# Physics based justification on $C_p$ value ratification

(A presentation in support of draft 1.4 comments #115, #116 and #117)

January 13, 2021

bois\_3ck\_adhoc\_01\_011321

# Current topology for reference package (continued)

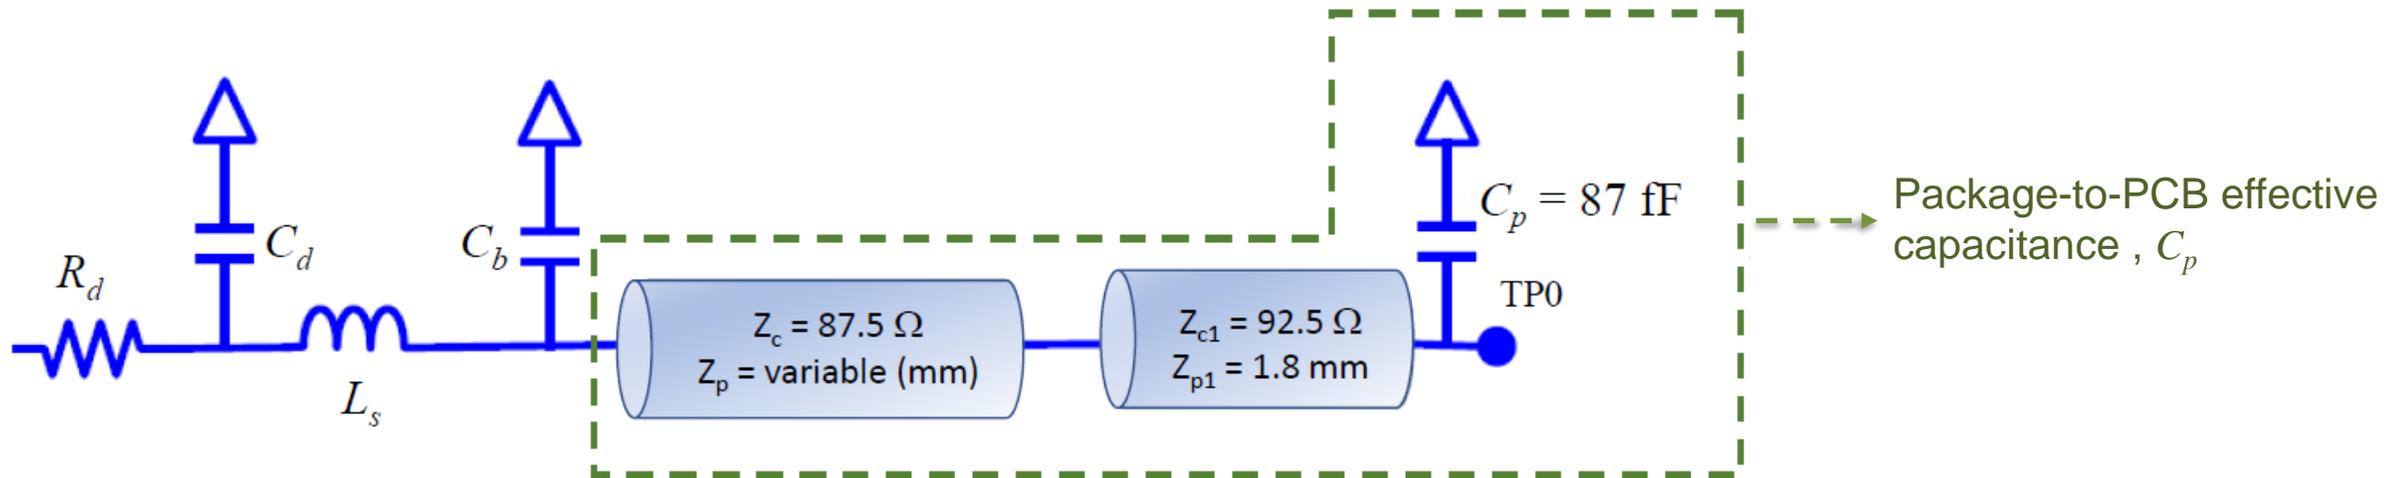
- The small effective transmission line section of the BGA is modeled using a shunt capacitor,  $C_p$ .
- Important note: modeling setup in 3D electromagnetic solvers will include a fraction of the PCB pad to BGA interface for port setup. Concatenated model overestimates the impact of the BGA region.

- As per comment for change request (#115, #116 and #117),  $C_p$  to be lowered to 60 fF.
- The proposed value translates to more accurate physical characteristic impedance of transmission line in the BGA field.
- The resulting impact of change: COM results for channel evaluation track more realistically physical implementation performance.
